SOMS # 160550

**Re: GE-Pittsfield/Housatonic River Site
Floodplain Residential and Non-Residential Properties Adjacent to 1 ½ Mile
Reach of Housatonic River (GECD710 and GECD720)
Work Plan Addendum – Phase 1, Group 1A and 1B Properties**

PRE-DESIGN INVESTIGATION WORK PLAN ADDENDUM FOR
FLOODPLAIN PROPERTIES ADJACENT TO THE 1 1/2 MILE REACH -
PHASE 1, GROUP 1A & 1B

FIGURE
1-1

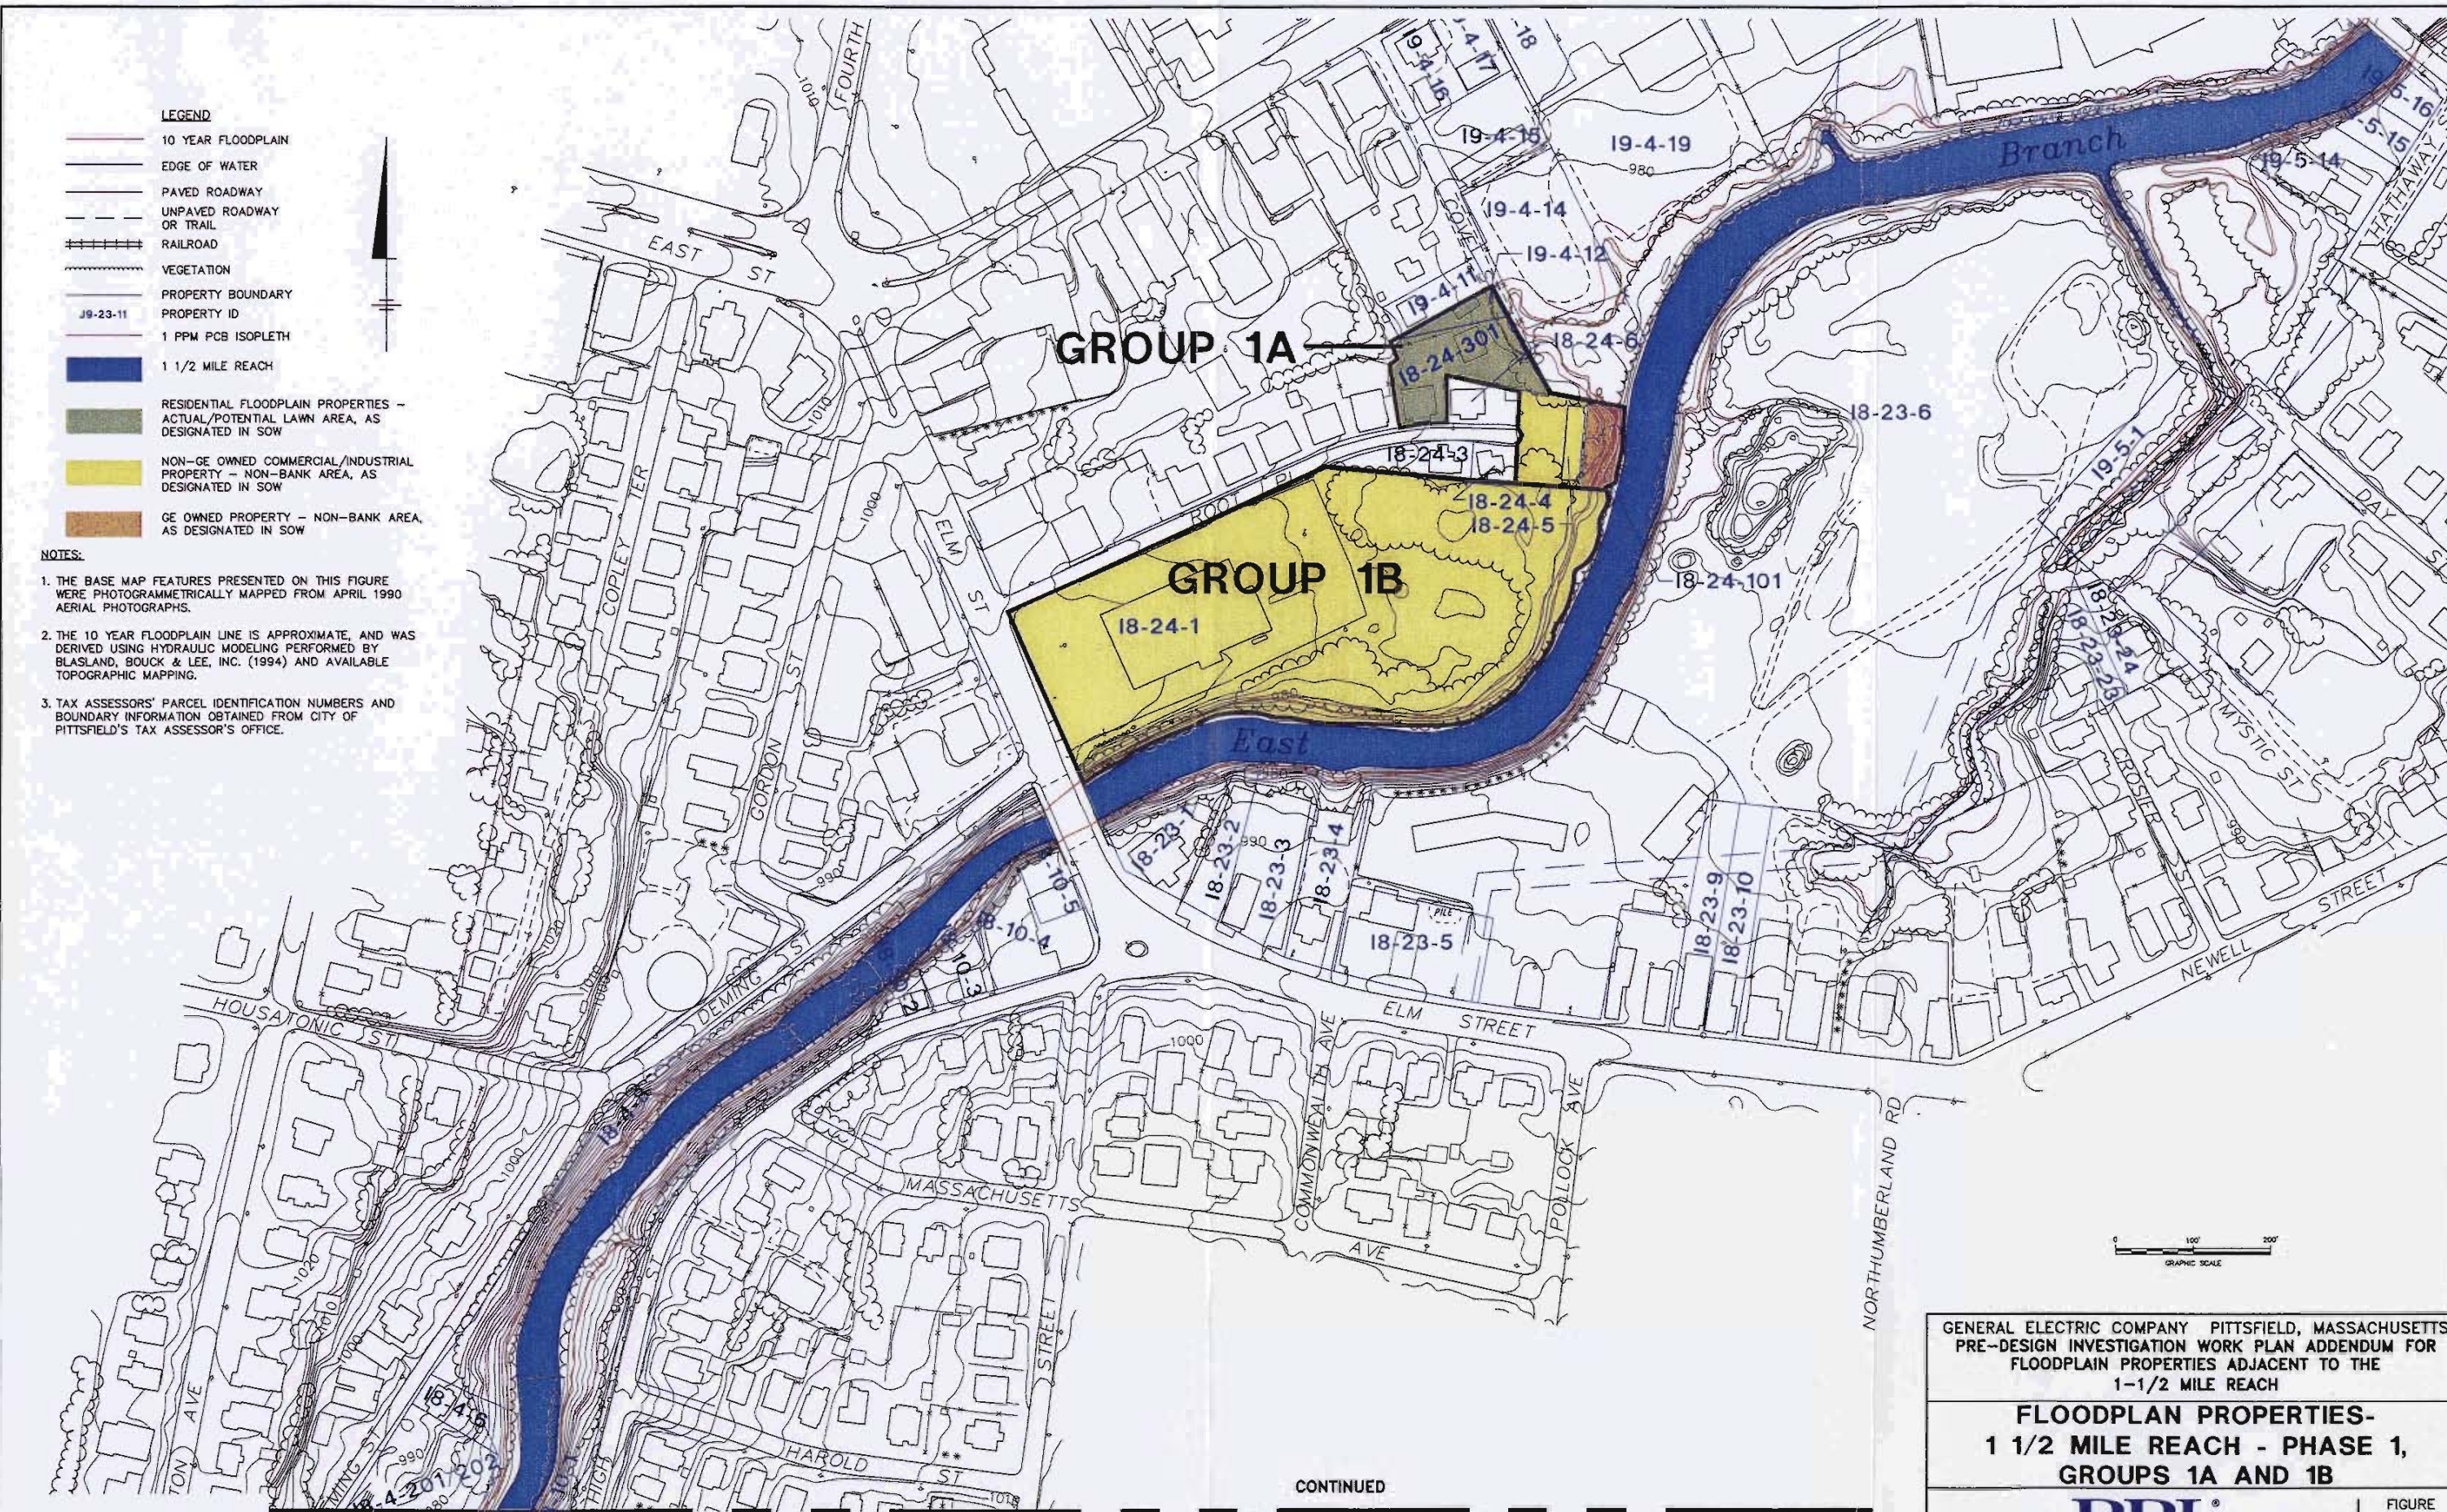
1. EPA Specific Condition No. 1 for the Phase 1, Group 1A and 1B properties states that Parcel I8-24-6 and Parcel I9-4-13 were recently combined into Parcel I8-24-301 for tax purposes and that, as such, additional pre-design sample locations should be identified in the Addendum (for Parcel I8-24-6). However, based on review of the City of Pittsfield Tax Assessors' Records, GE has determined that it was Parcel I8-24-7 (rather than Parcel I8-24-6) that has been combined with Parcel I9-4-13 to form Parcel I8-24-301. GE has revised Figures 1-1 and 4-1 to identify the new boundary of Parcel I8-24-301.

2. GE has revised Figure 1-1 (which depicts the Phase 1, Group 1A and 1B properties) and Figures 4-1 and 4-2 (which depict existing and proposed PCB sampling locations for the subject properties) to include the 10-year floodplain boundary and the available topographic contour lines. In addition, Figure 1-1 and 4-1 have been revised to indicate a change in the designated land use for Parcel I9-4-12. The SOW, and more recently the PDI Work Plan, had identified this parcel as a non-residential/non-commercial property. However, a recent reconnaissance performed by GE identified this parcel as a residential property. Based on a review of the proposed initial soil investigations, this change in property use designation does not warrant a modification to the initial pre-design sampling locations, since the spacing of the proposed sample locations on this parcel is generally consistent with those at the adjacent residential property (now Parcel I8-24-301). However, samples from the proposed soil boring on Parcel I9-4-12 will be collected from depth increments consistent with those identified for residential properties in the PDI Work Plan (i.e., 0 to 1 foot, 1 to 3 feet, 3 to 5 feet, 5 to 7 feet, and 7 to 9 feet).
